CONTRACT NO. 1760 G, E, H, P

CSO BYPASS AND DISINFECTION

ADDENDUM NO. 5

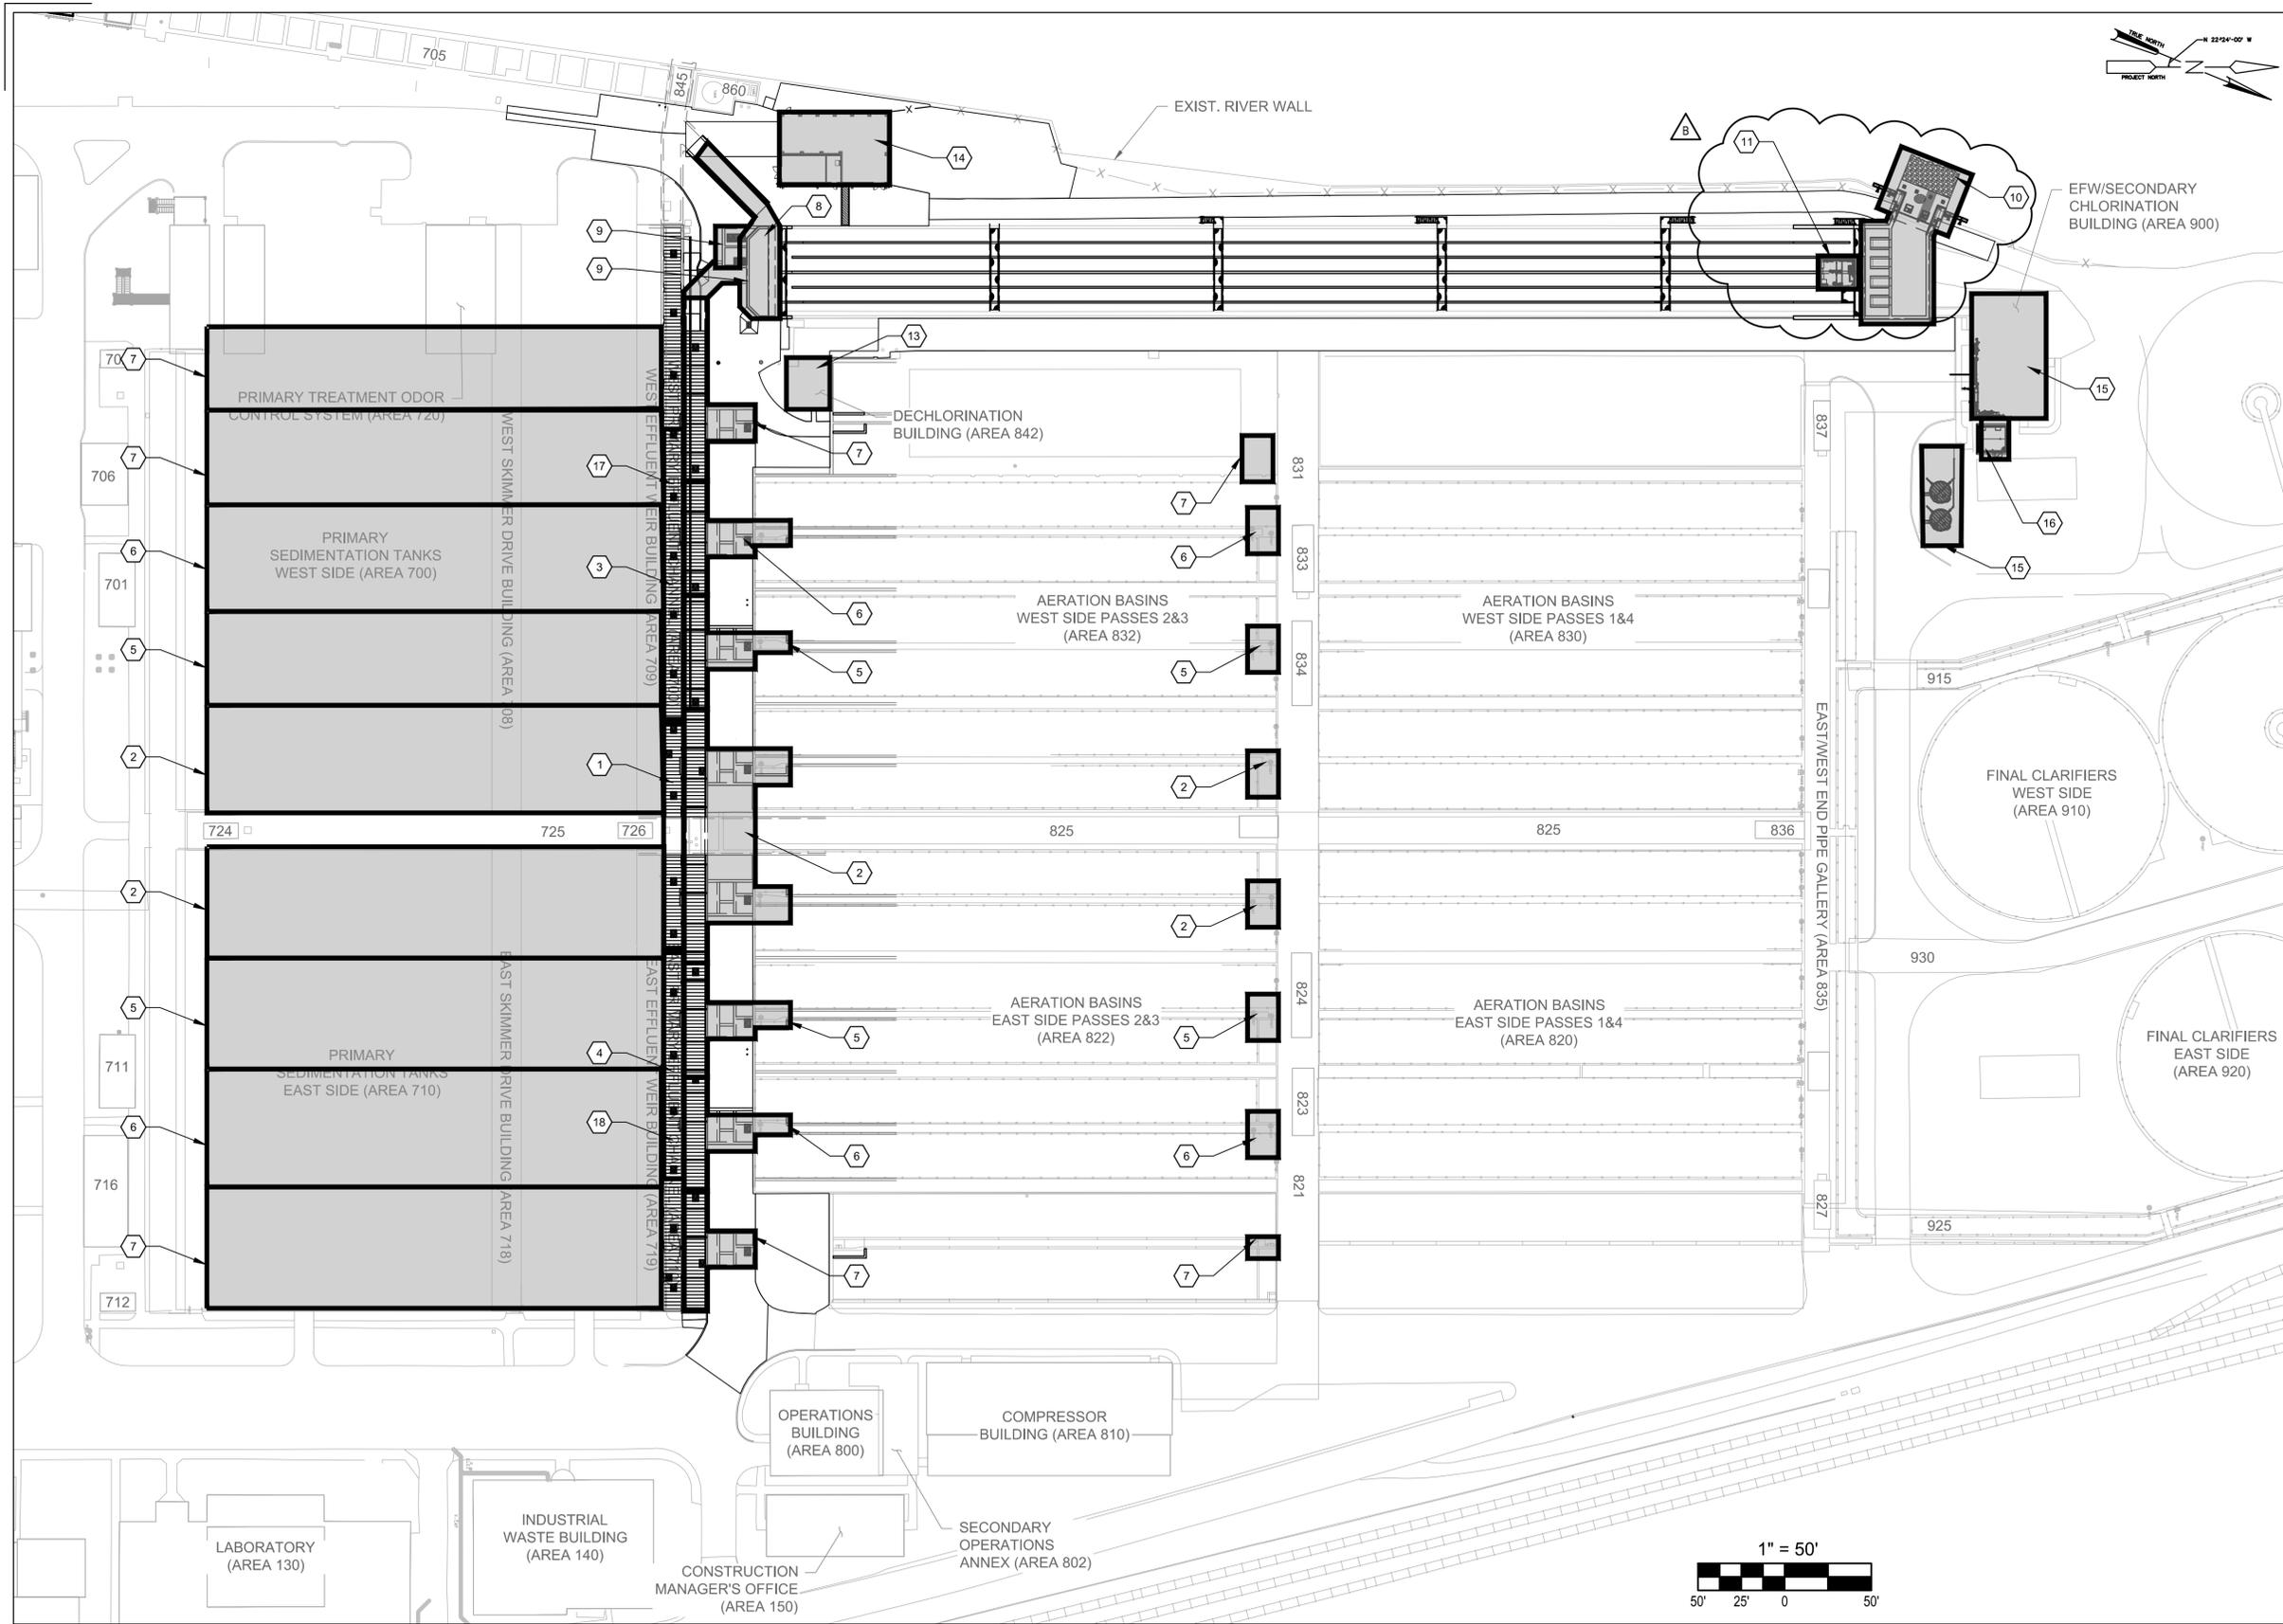
1. Replace drawing 000-SD-64 with the attached updated sheet.
2. Replace drawing 822-S-60 with the attached updated sheet.
3. Replace drawing 000-G-12 with the attached updated sheet.

154. **Question:** Reference drawing 000-G-12 (sheet 10) and specification 01 52 00 MoPO Work Area 840.3: There’s a disconnect between these two documents. The drawing shows three shaded areas 10, 11, & 12 at the north end as 840.3, 840.4, & 840.5. The shaded area 12 (840.5) isn’t over the Sampling Building, but south of it. The MoPO indicates the Sampling Building as Area 840.3 but the drawing indicates that the north end new Effluent Chamber is 840.3. The MoPO description of Work Area 840.4 references 840.3 & 840.5. Please clarify.

Answer: Refer to updated 000-G-12 and Section 01 52 00.

AERATION BASIN MODIFICATION - PLAN
SCALE: 1/4"=1'-0"
822-S-10

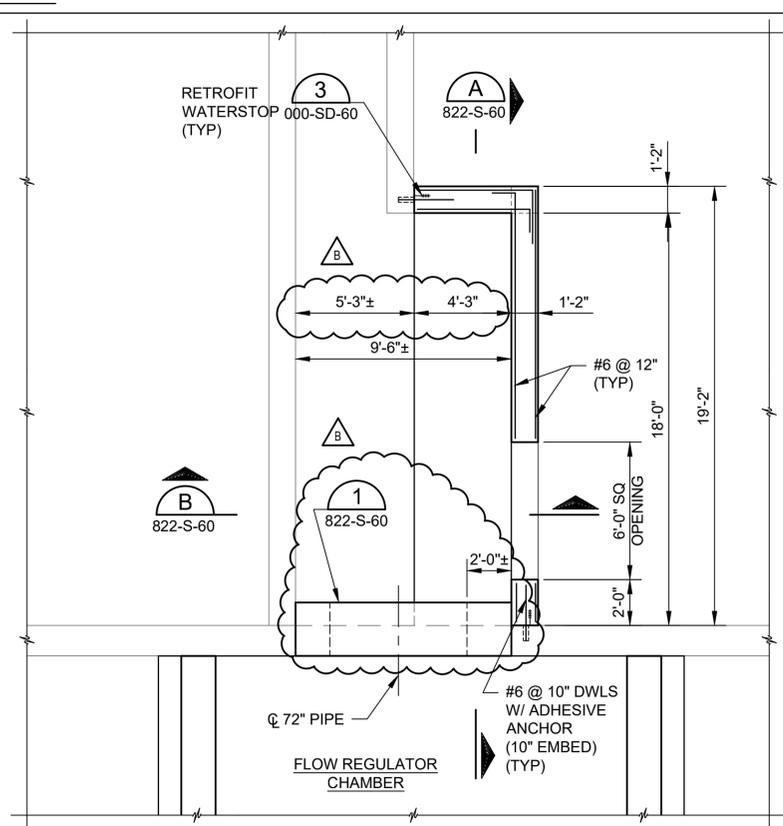
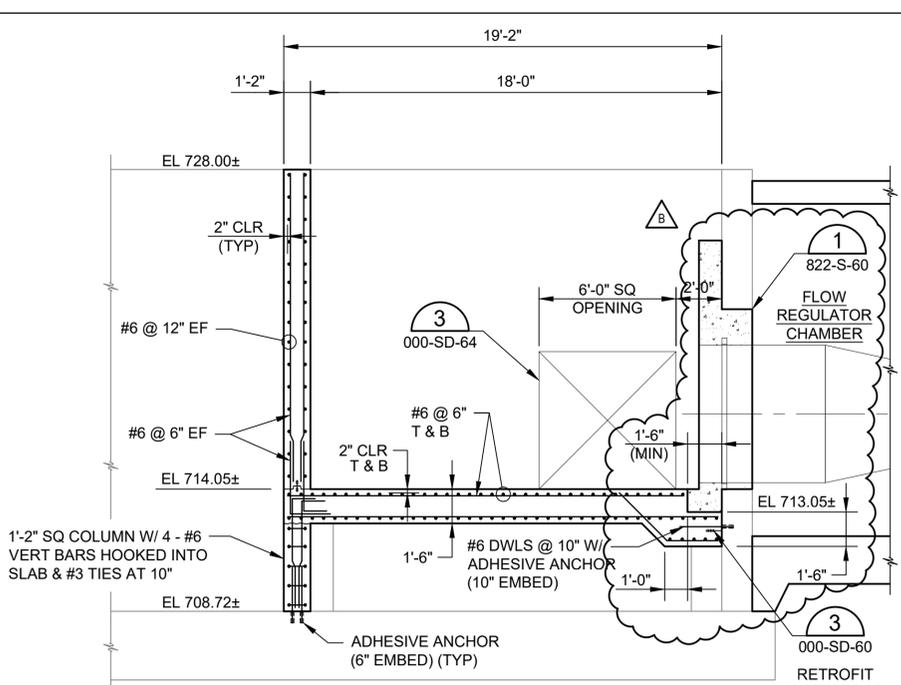
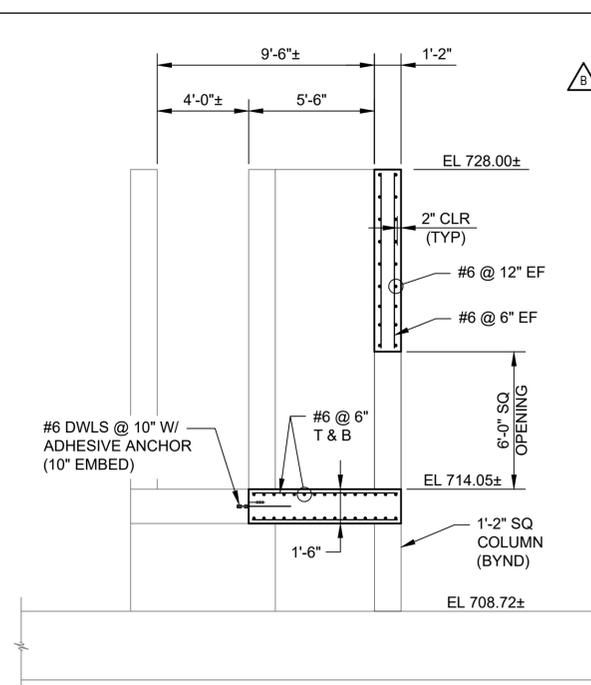
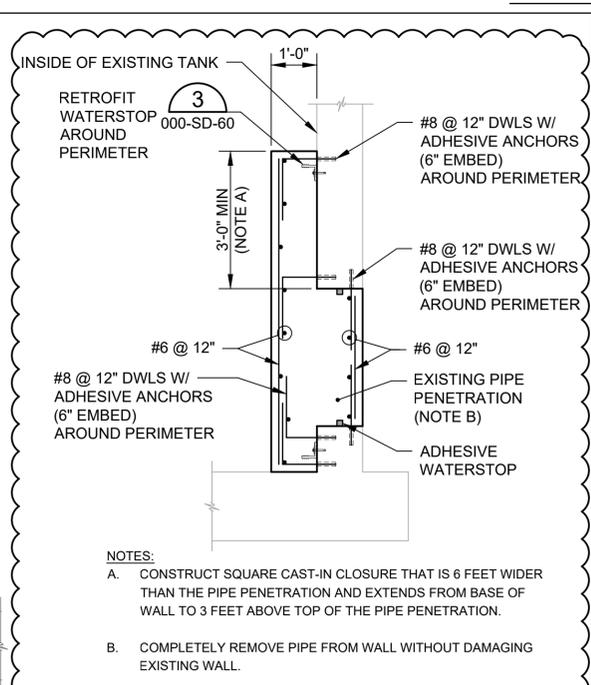
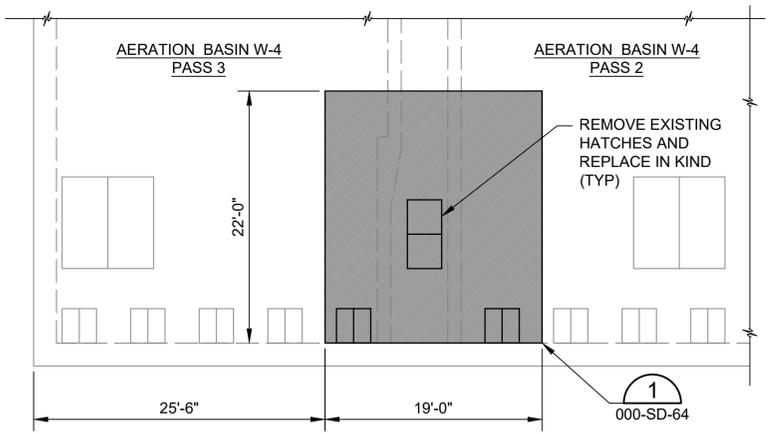
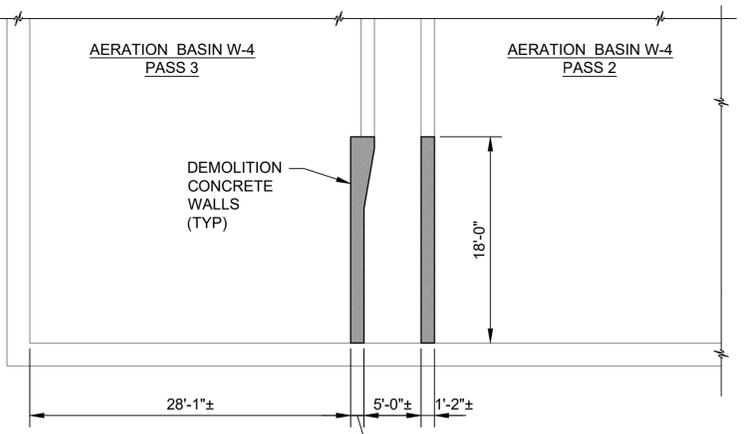
Question: Reference drawing 822-M-40 (sheet 175): Regarding the replacement of the flow regulator pipe. Note that the existing centerline locations of the existing are different than the centerline locations of the new pipe. Since these will be significant in size, please provide a more specific detail, other than the general patching detail (SD64 on sheet 69) provided. We request dimensioned, engineered details, for the cut-out, reinforcement, and patch-back of the existing walls on both the effluent channel and aeration tank sides of the flow regulator chambers.

Answer: Refer to the updated structural drawings in this addendum.

842-ES-02
DECHLORINATION BUILDING 842
CONDUIT AND CABLE SCHEDULE

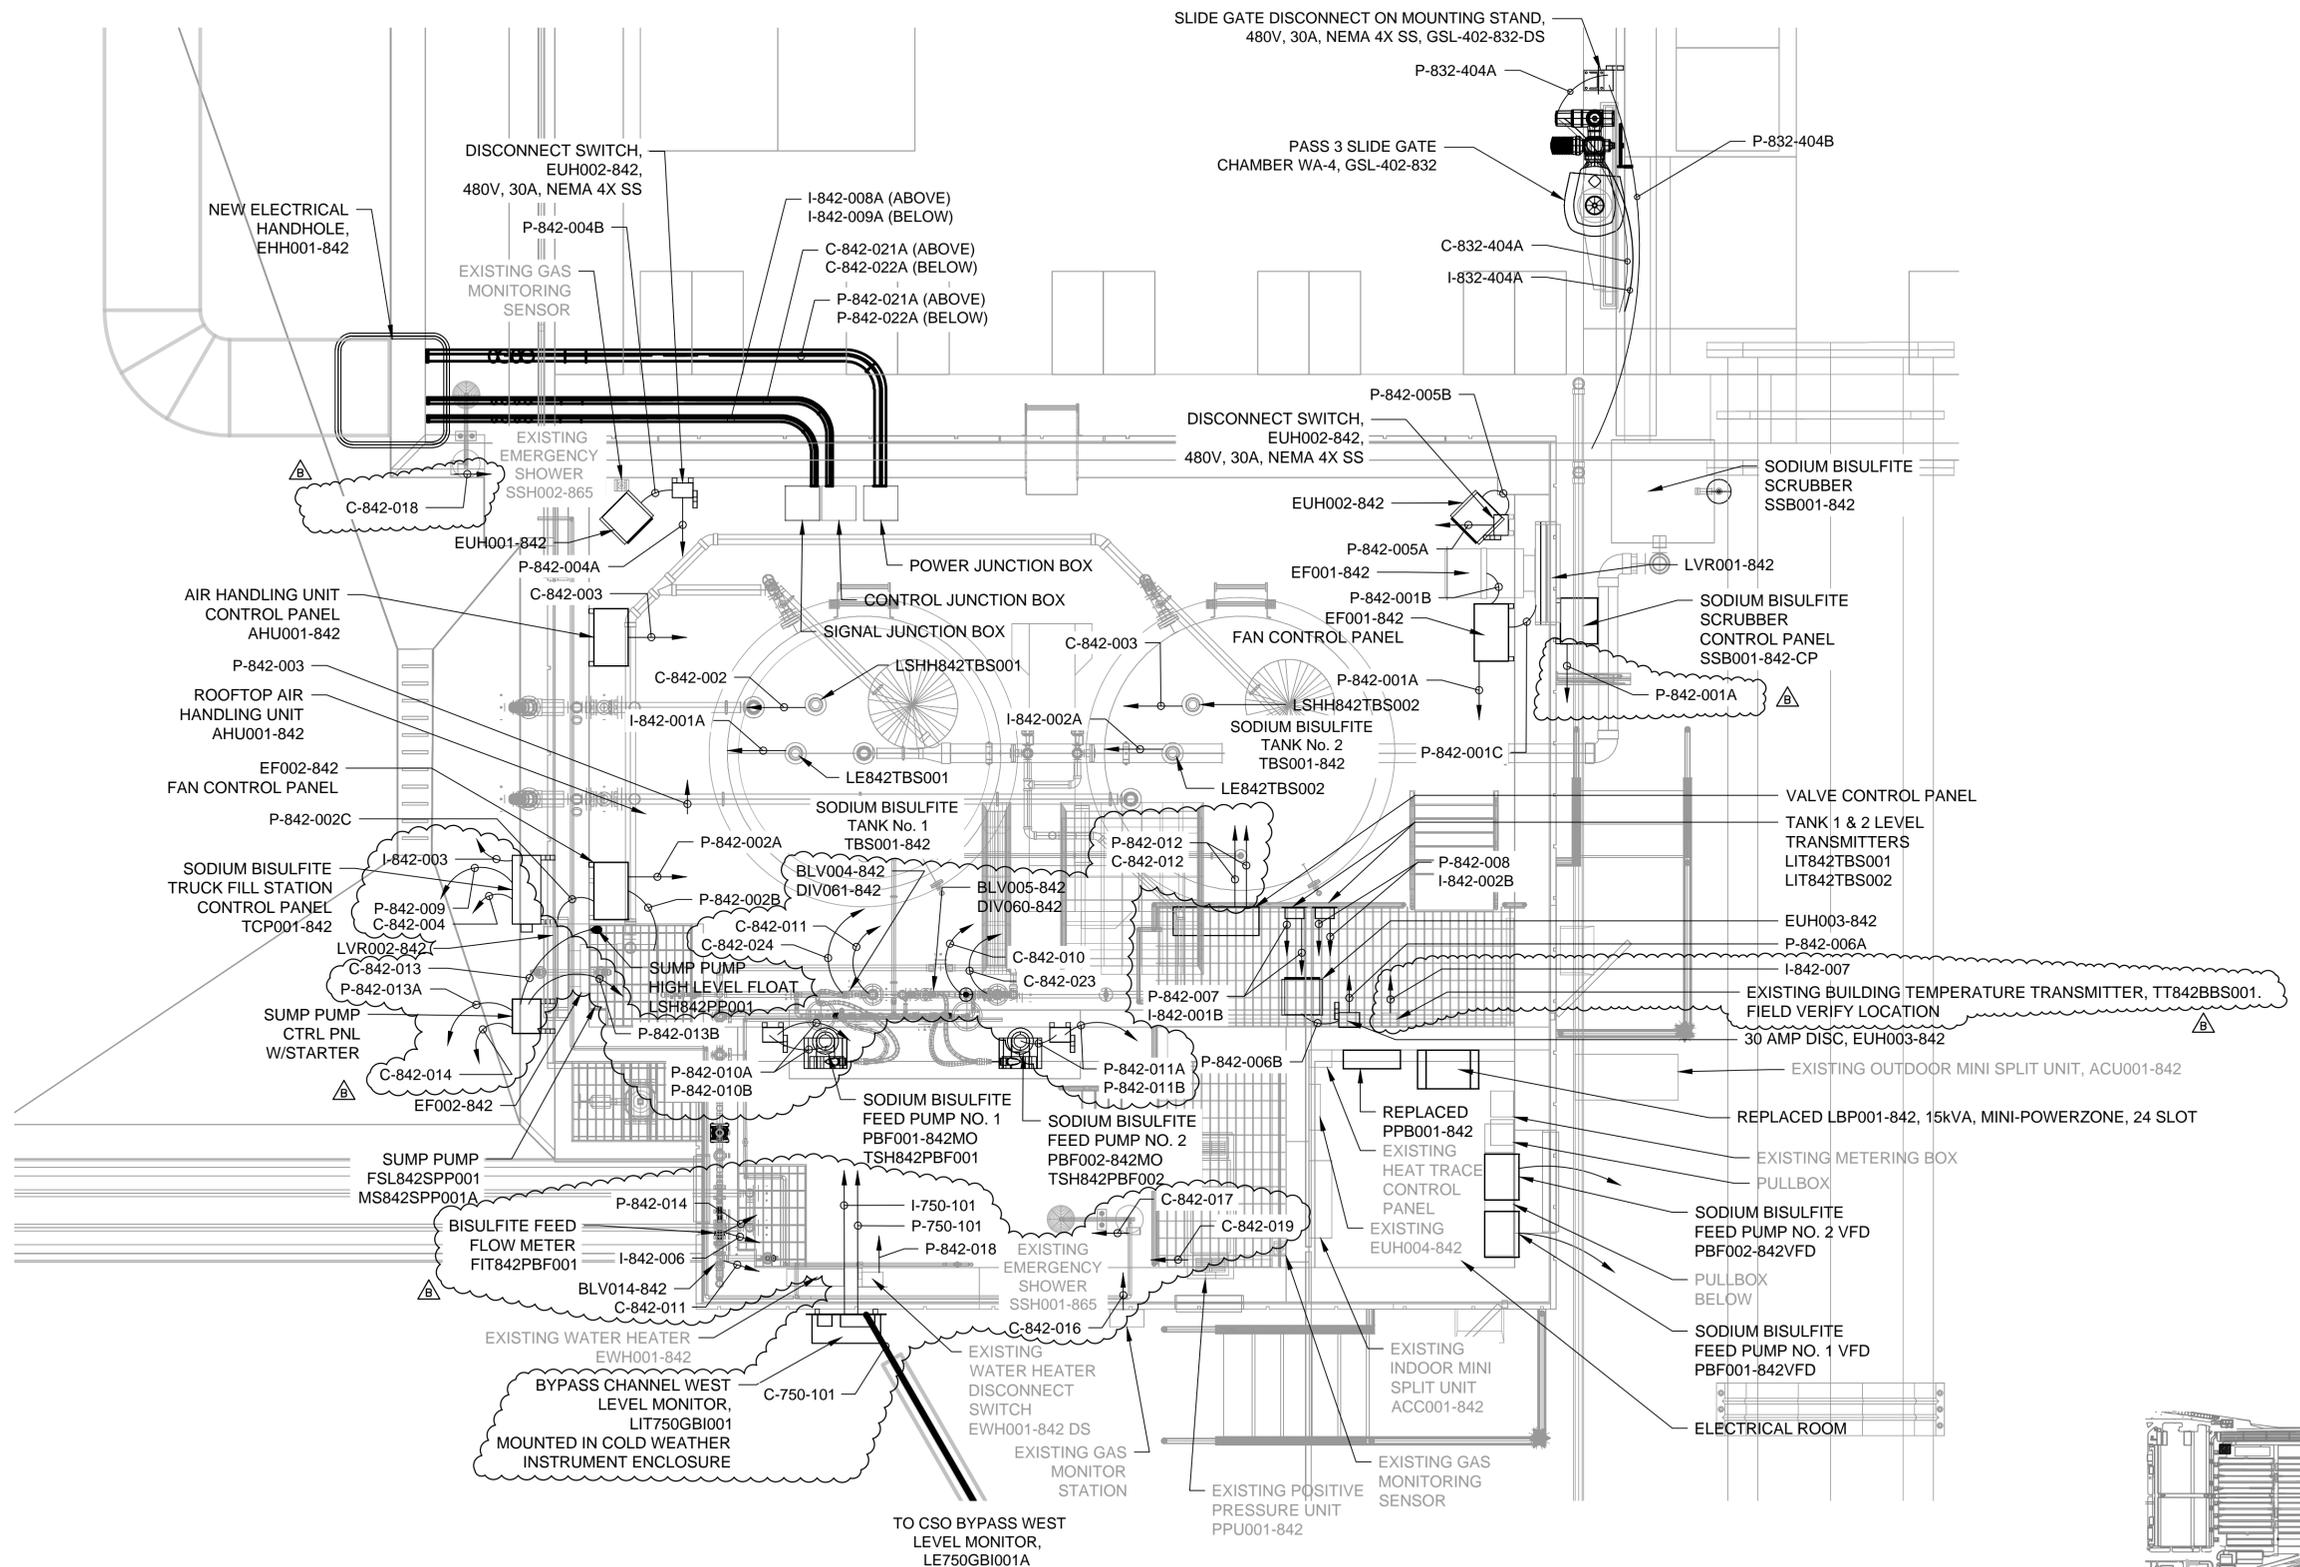
6. On drawing 840-ET-12, Slide Gates No. 1 through 7, delete the conduits tagged 1-840-101 through 1-840-107
7. Replace drawing 842-ES-02 with the attached updated sheet

181. **Question:** Drawing 842-ET-10 – Sodium Bisulfite Power Plane and Drawing 842-ES-02 Conduit and Cable Schedule - We are not able to find all of the Equipment listed on the Conduit and Cable Schedule on the Electric Power Plan. The Conduit Tags and Equipment that we are not able to find on the drawings is listed below.

Answer: Refer to updated drawings.

ALLEGHENY COUNTY SANITARY AUTHORITY
WASTEWATER TREATMENT PLANT
CSO BYPASS AND DISINFECTION PROJECT
842-ET-10
SODIUM BISULFITE BUILDING
ELECTRICAL POWER PLAN

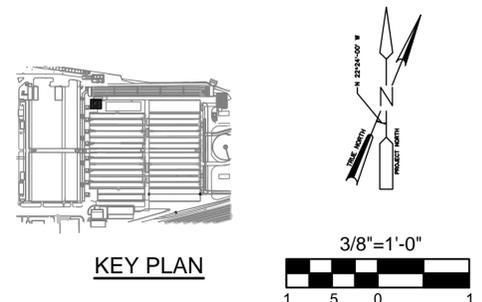
8. Replace drawing 842-ET-10 with the attached updated sheet.
9. Replace drawing 842-I-01 with the attached updated sheet.
10. Replace drawing 842-M-41 with the attached updated sheet
